Title - Sujet Reconstruction Quais 97 & 98	
Solicitation No. - N° de l'invitation EE517-142232/A	Amendment No. - N° modif. 010
Client Reference No. - N° de référence du client EE517-14-2232	Date 2014-05-16
GETS Reference No. - N° de référence de SEAG PW-\$QCM-008-15898	
File No. - N° de dossier QCM-3-36330 (008)	CCC No./N° CCC - FMS No./N° VME
Solicitation Closes - L'invitation prend fin at - à 02:00 PM on - le 2014-05-28	Time Zone Fuseau horaire Heure Avancée de l'Est HAE
F.O.B. - F.A.B. Plant-Usine: <input type="checkbox"/> Destination: <input checked="" type="checkbox"/> Other-Autre: <input type="checkbox"/>	
Address Enquiries to: - Adresser toutes questions à: Rochette, Jean	Buyer Id - Id de l'acheteur qcm008
Telephone No. - N° de téléphone (418) 649-2834 ()	FAX No. - N° de FAX (418) 648-2209
Destination - of Goods, Services, and Construction: Destination - des biens, services et construction:

Title : RECONSTRUCTION OF WHARVES 97 & 98

PUBLIC WORKS AND GOVERNMENT SERVICES CANADA
QUAIS DE LA REINE - RECONSTRUCTION OF WHARVES 97-98
(PROJET N° 052833-001 & R.052834.001)

ADDENDUM N° 3

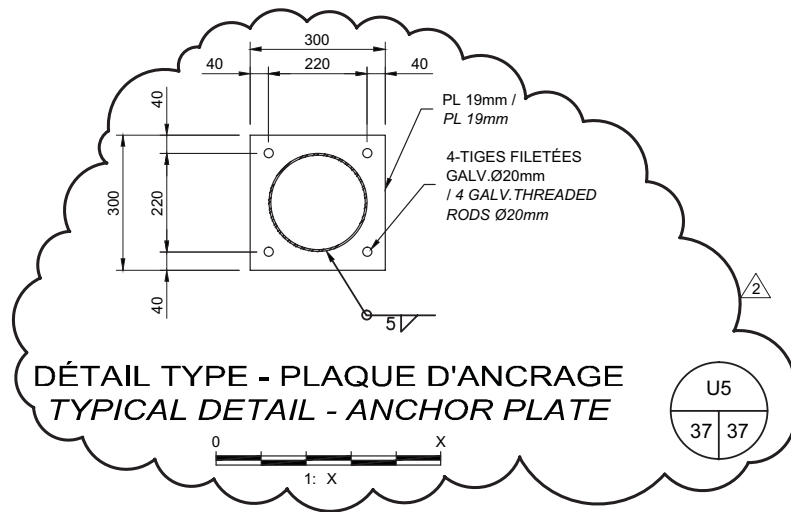
Sheet S30

Details are made on the frame around the pulling boxes.

nom du fichier/file name
QU-13-026M-S-37

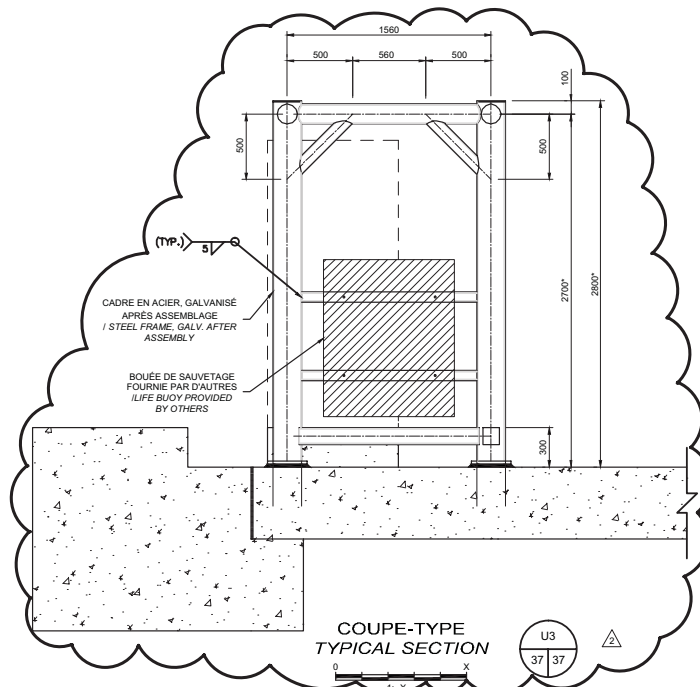
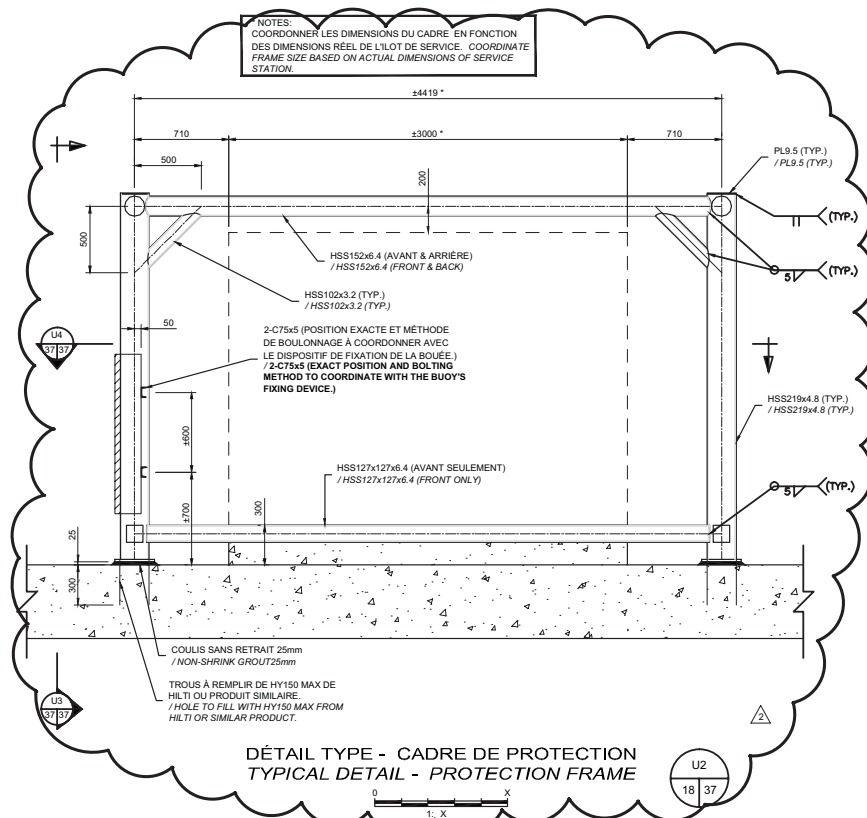
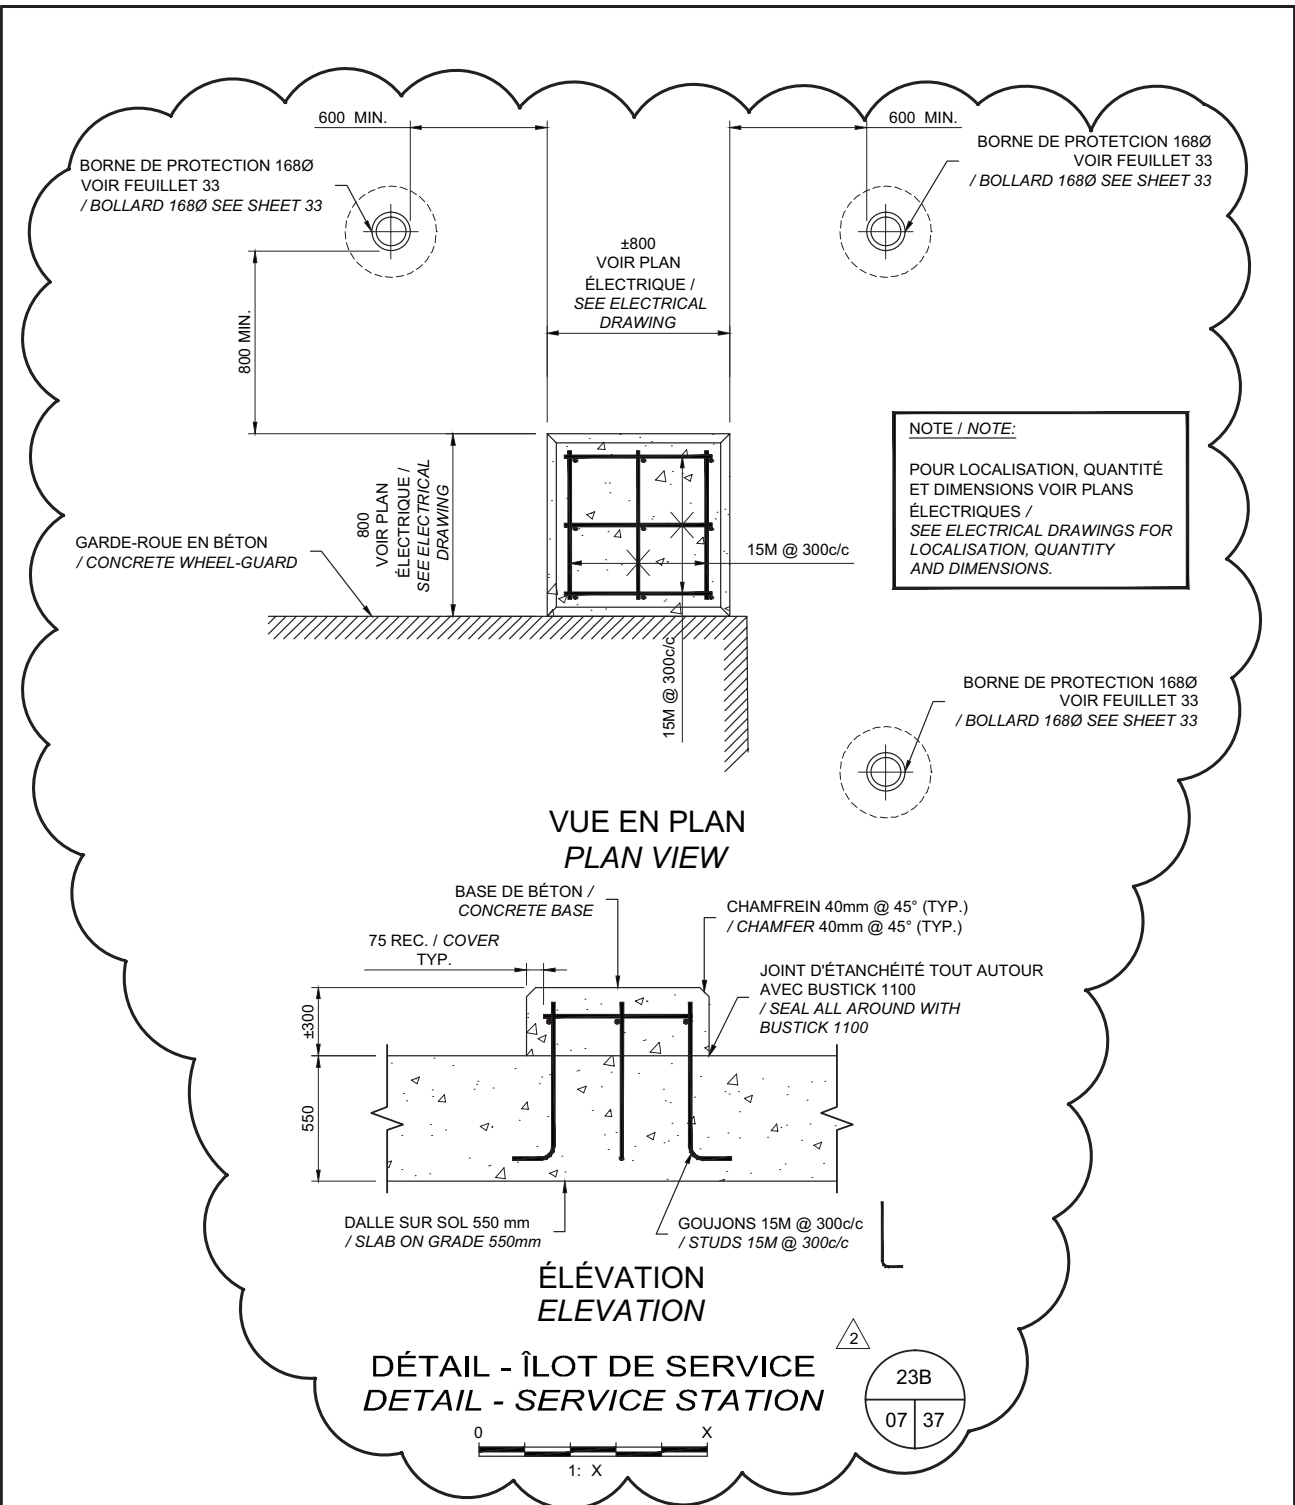
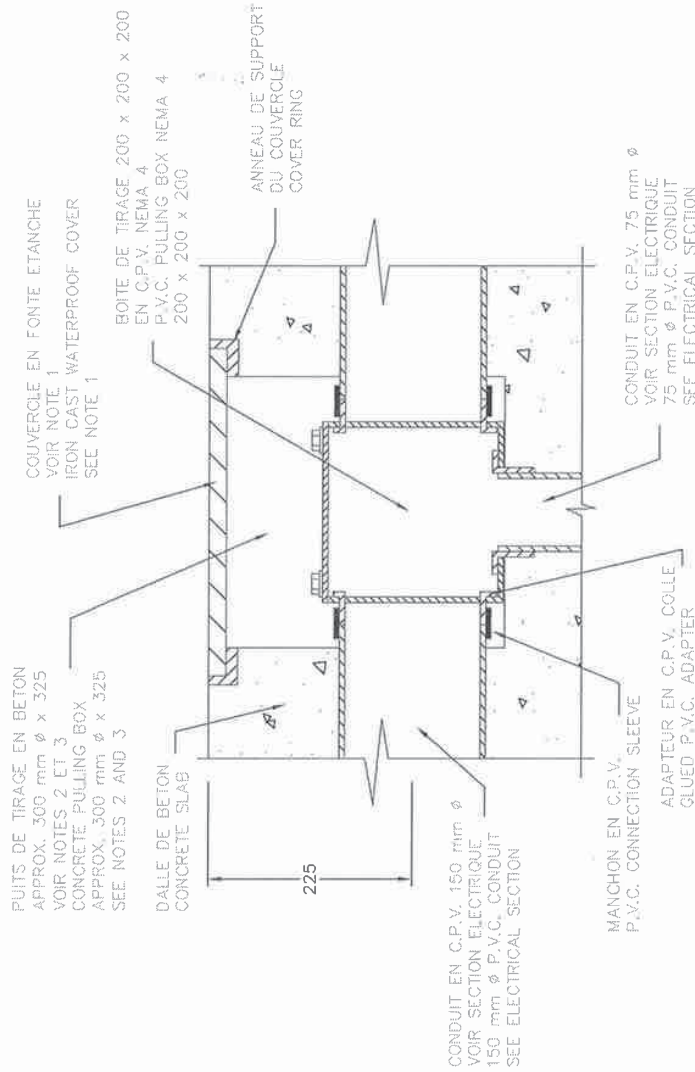
Sheet S37

Details are added for the protection frame.

Sheet S37

Details of the service station's slab of wharf 98 are added.

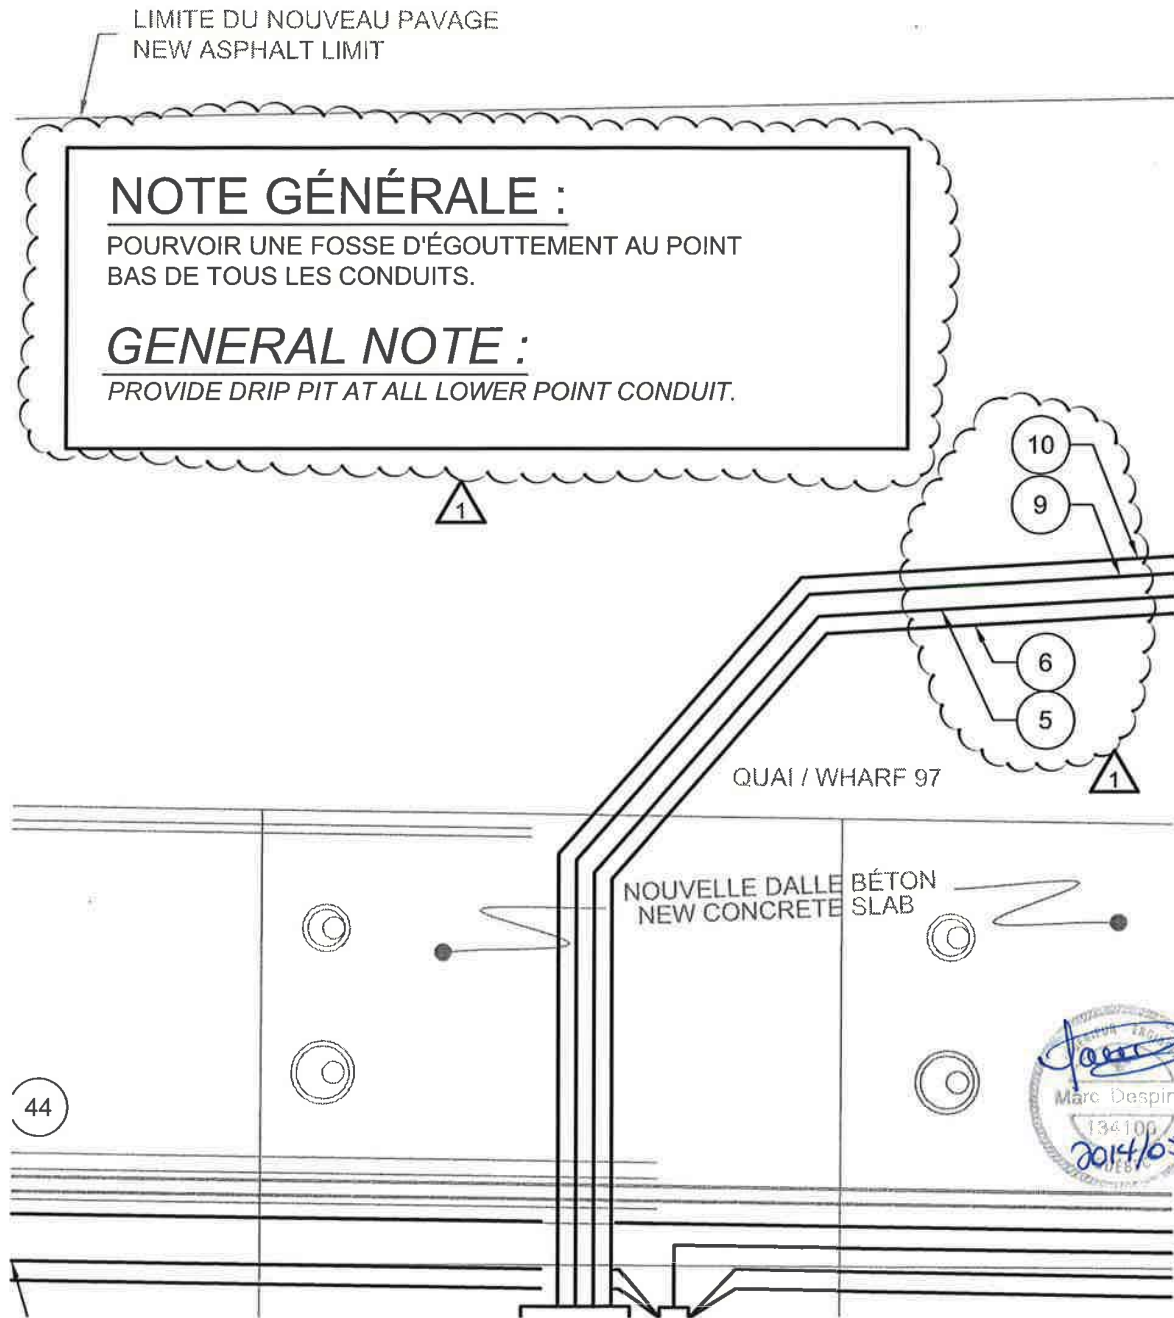
Sheet E01/03

Note 16 is modified (see extract E01/07).

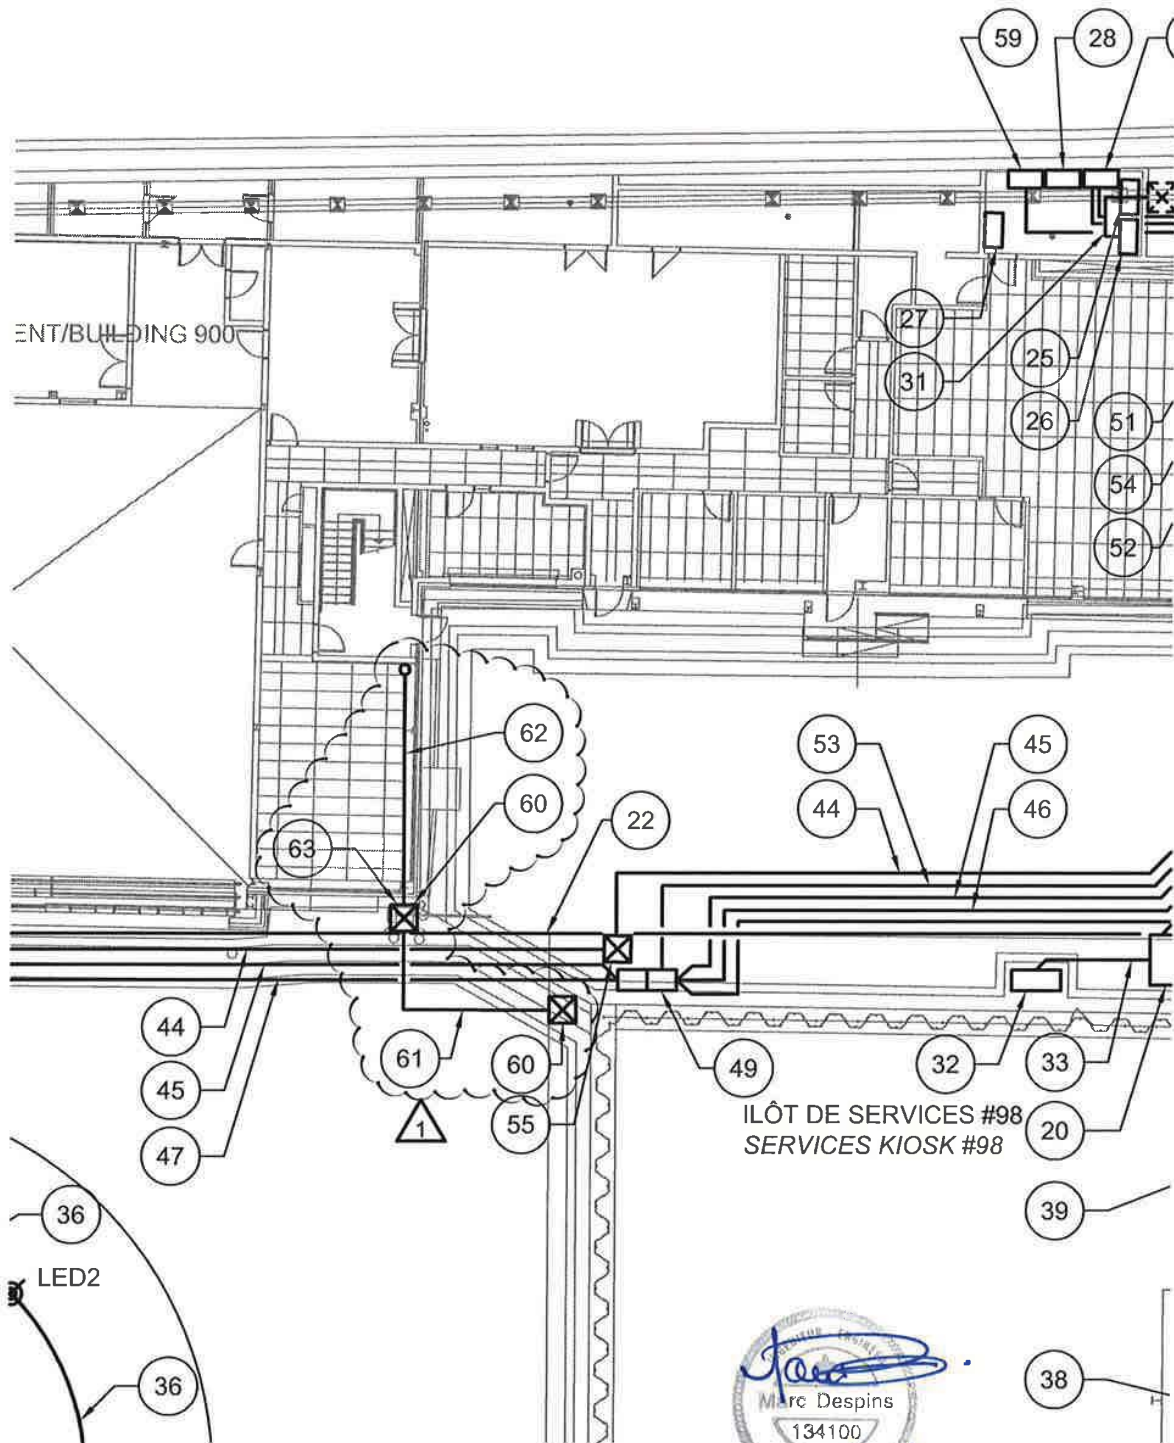
Sheet E02/03

Item identification 44 added (see extract E02/07).
